CITY OF PORTAGE PLANNING COMMISSION

AGENDA

TO: Planning Commission

SUBJECT: An application seeking Site Plan approval for Jiffy Lube automotive service station at 8516 Shaver Road.

EXTERIOR FINISH KEY

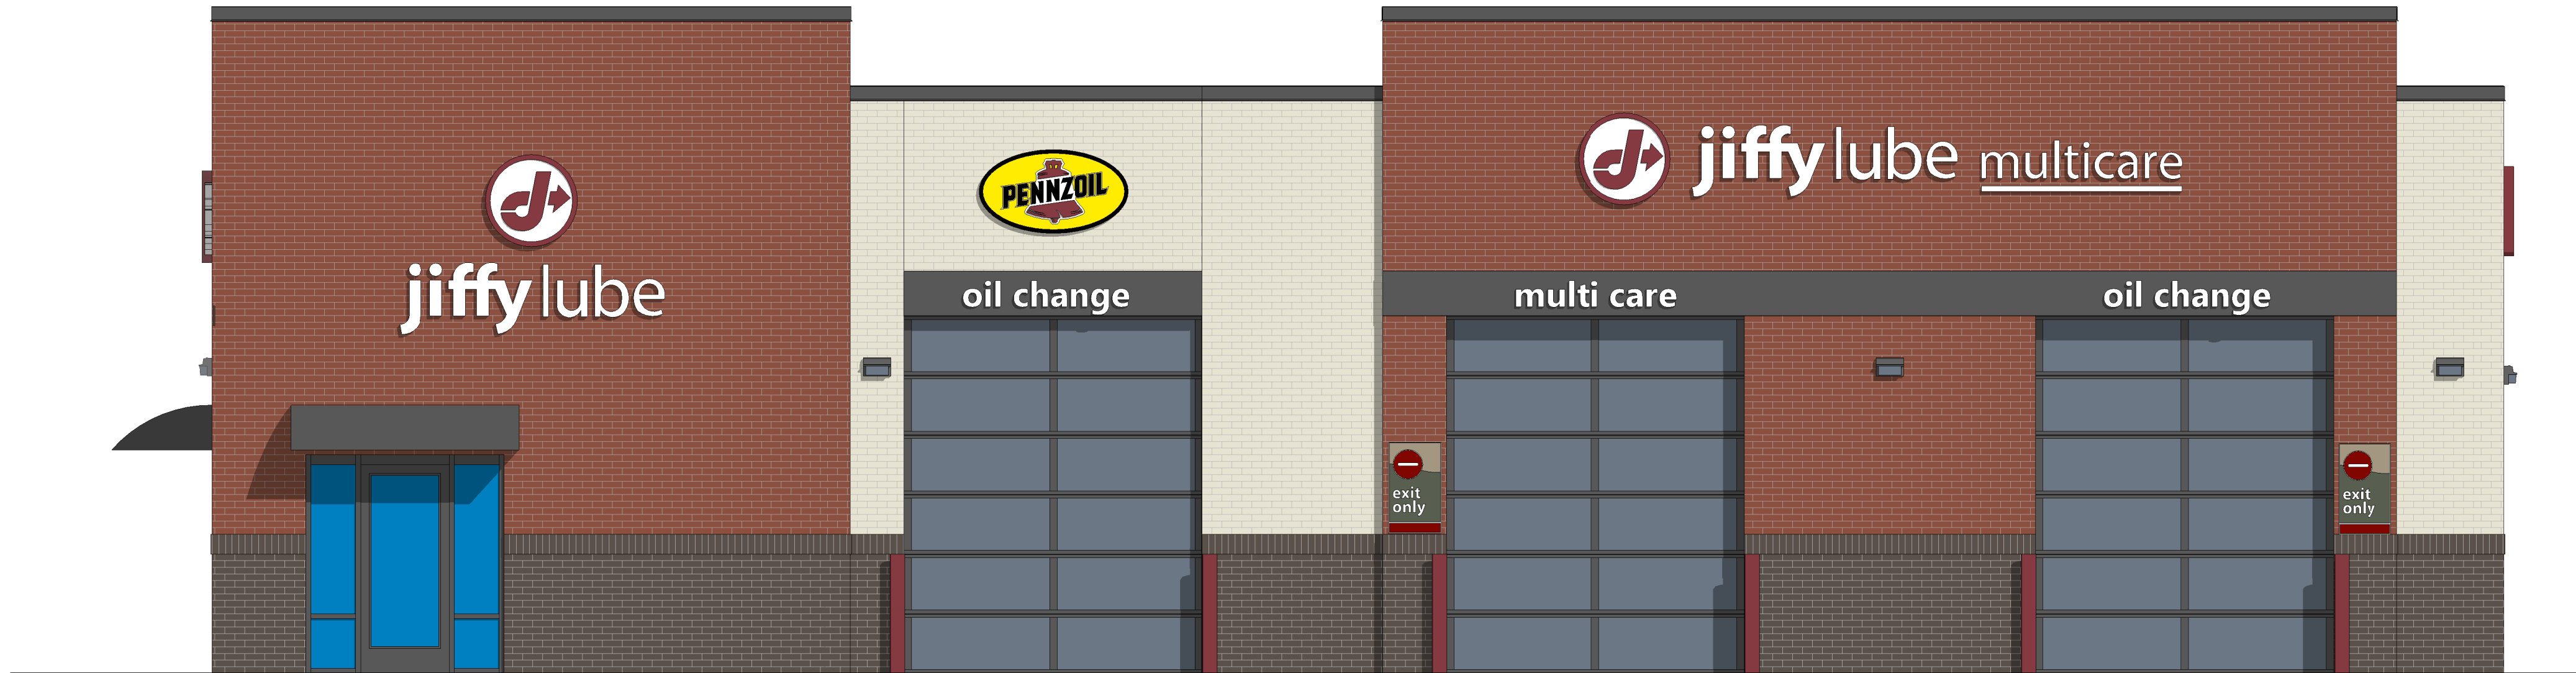
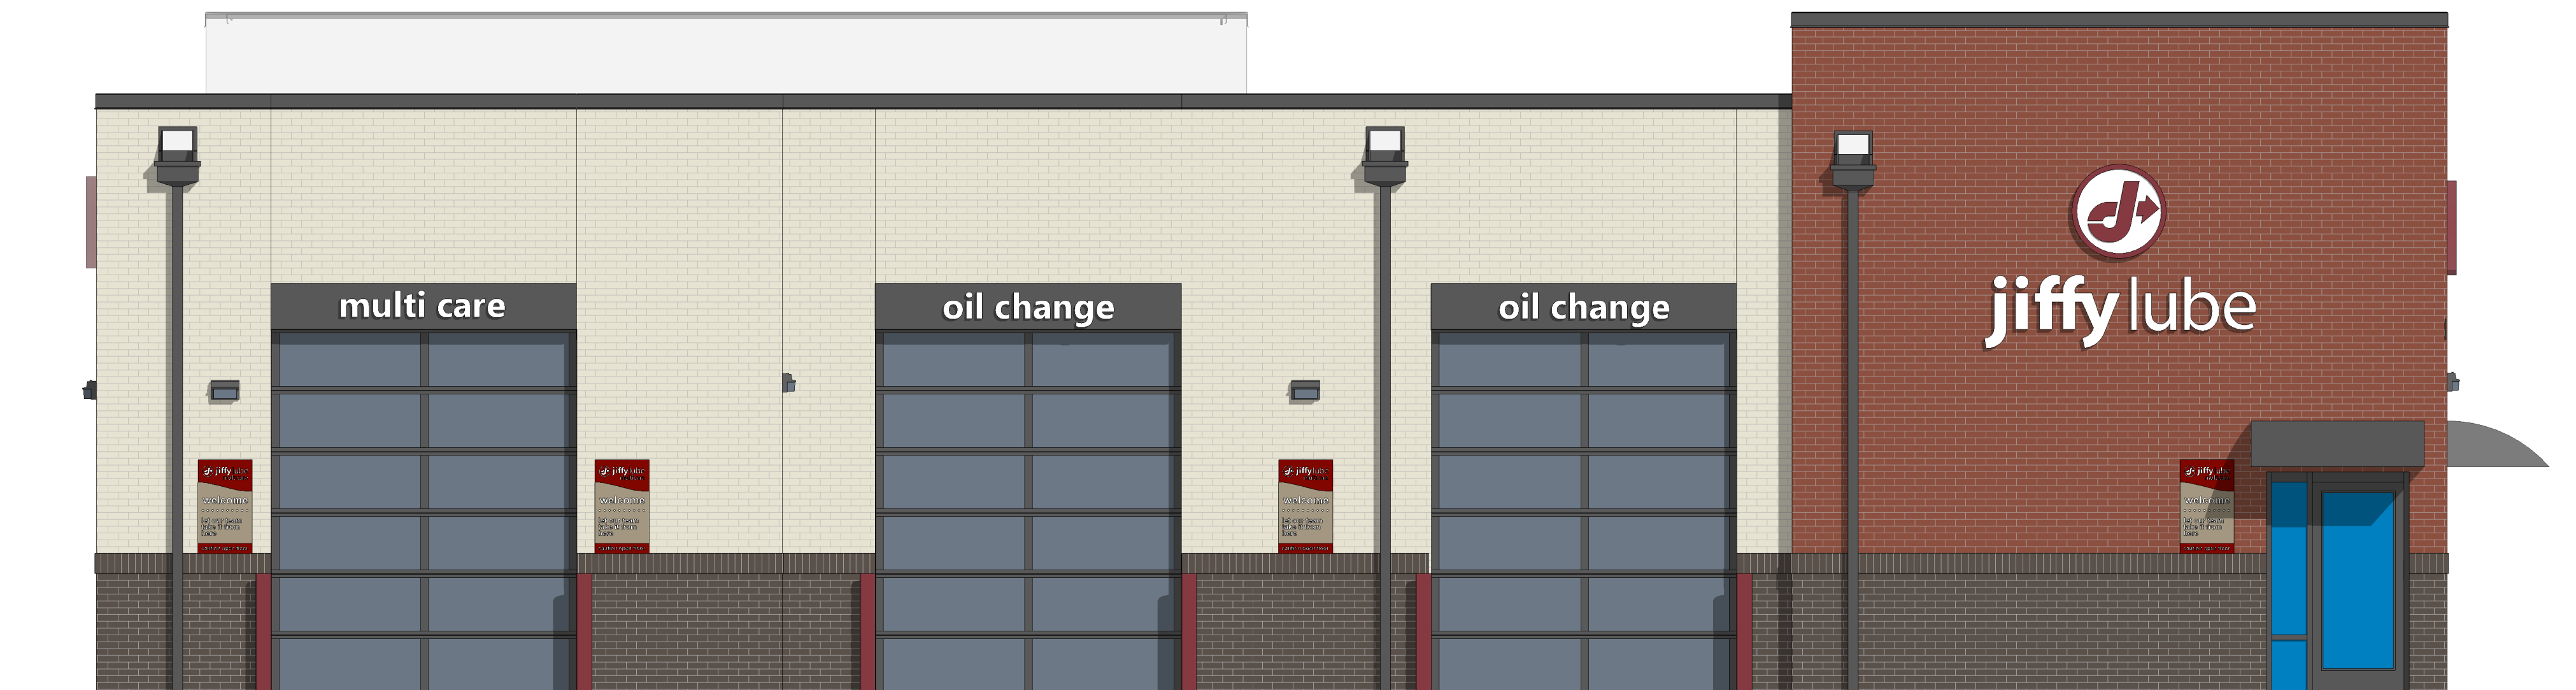
Although the review of exterior building material is not typical in a Site Plan nor often reviewed by the Planning Commission, this project lies within the CPD where specific development standards apply. The applicant is aware of the condition and has incorporated these elements. See attached proposed building designs.

1 CMU DUMPSTER ENCLOSURE
SCALE: 1/4" = 1'-0"

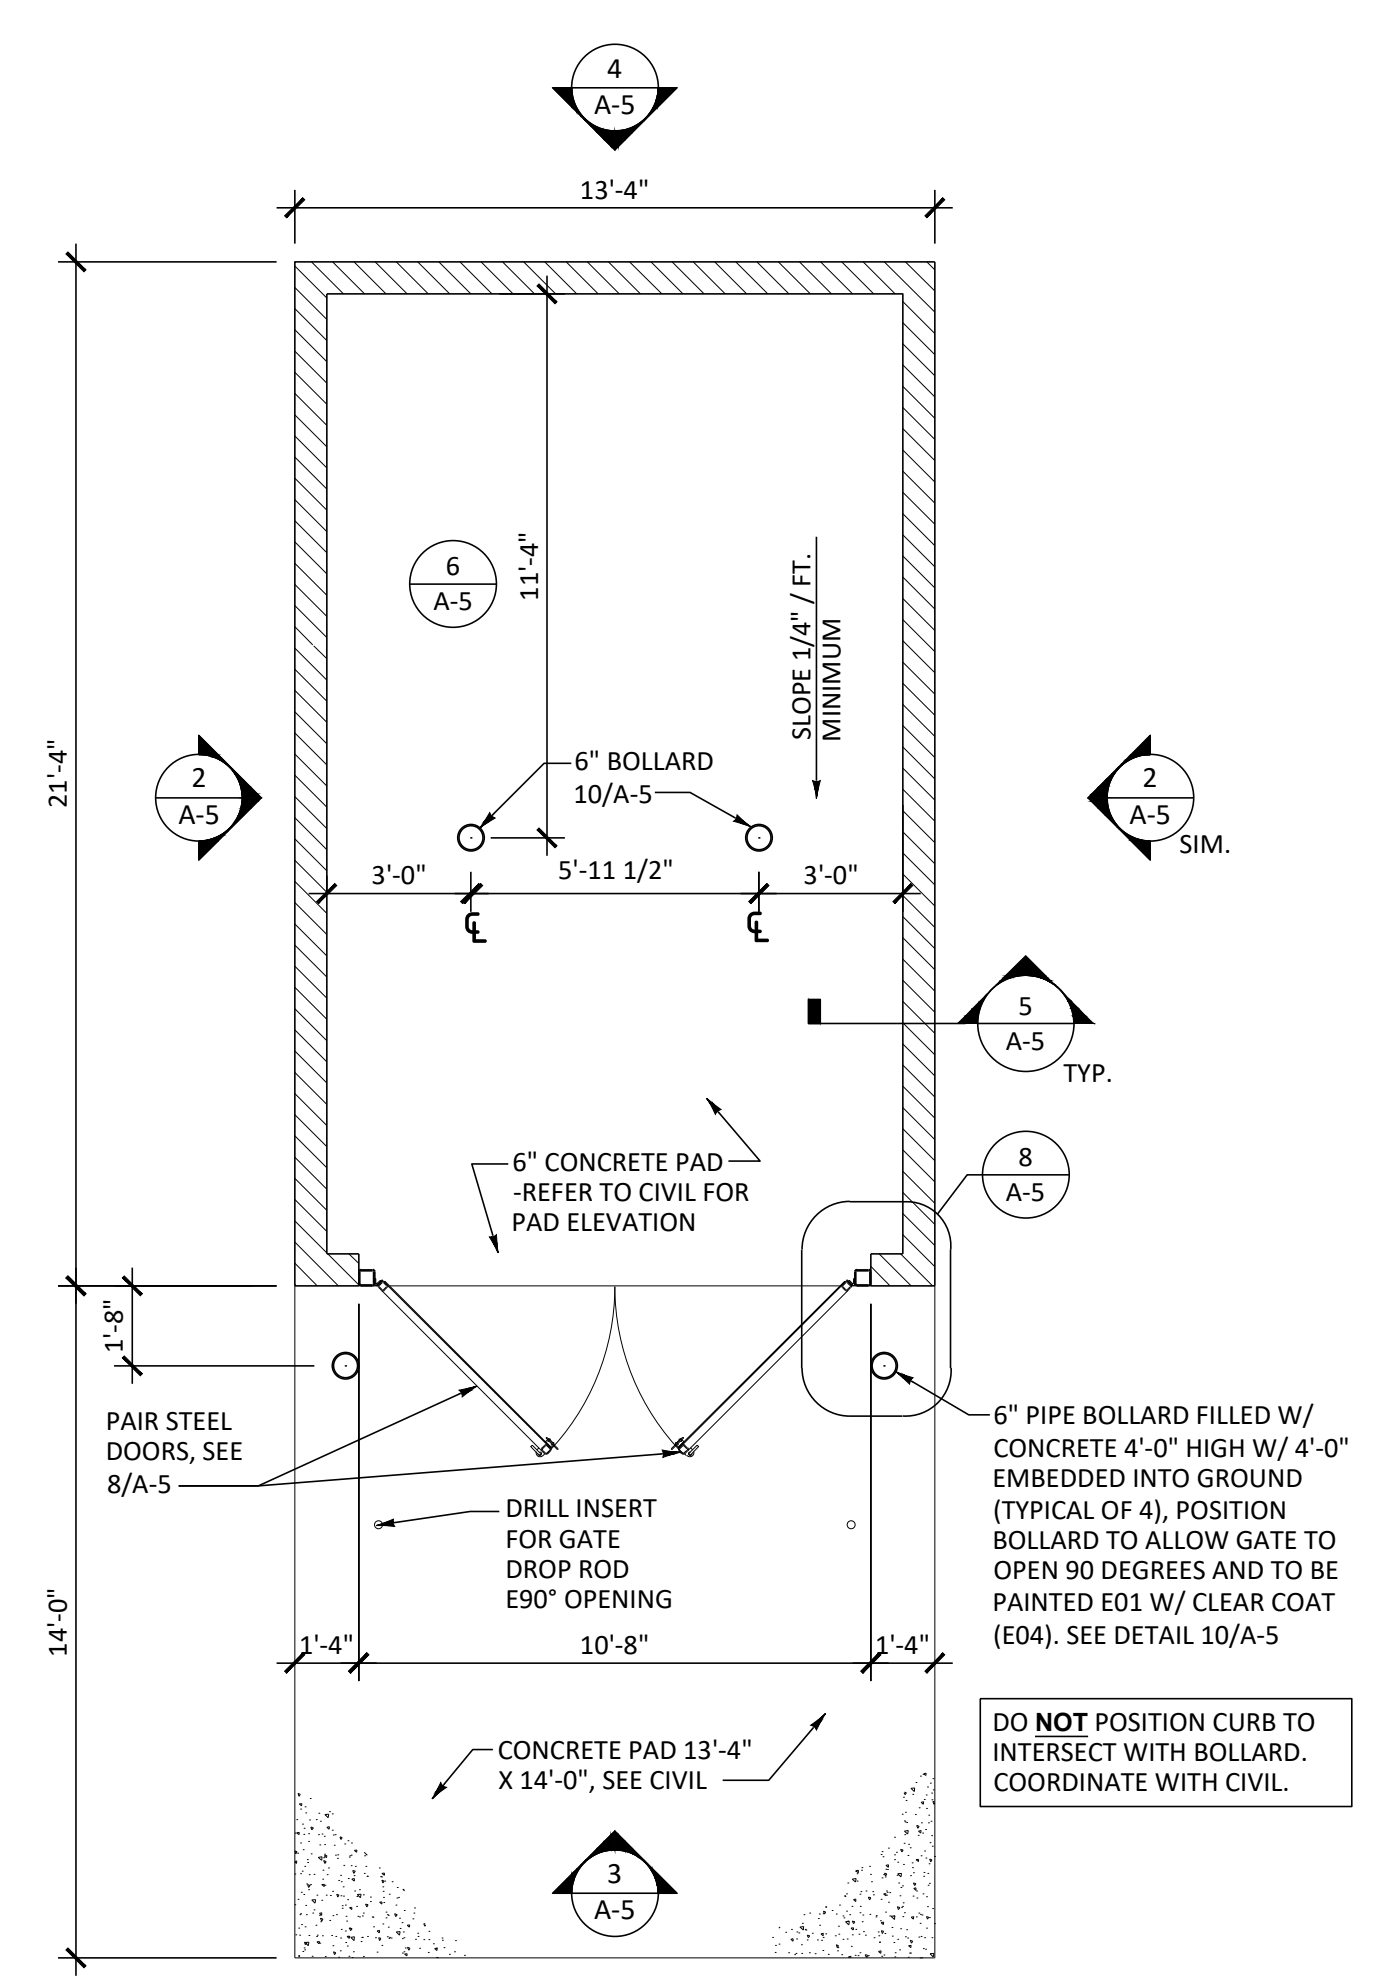
- **Refuse Enclosure:** Per Sec 42-574, an outdoor dumpster shall be located in an enclosure consisting of a six-foot tall (minimum) full opaque fence or wall. The applicant meets this by providing a refuse enclosure immediately north of the building, consisting of a 6’ 2" tall split-faced block wall.
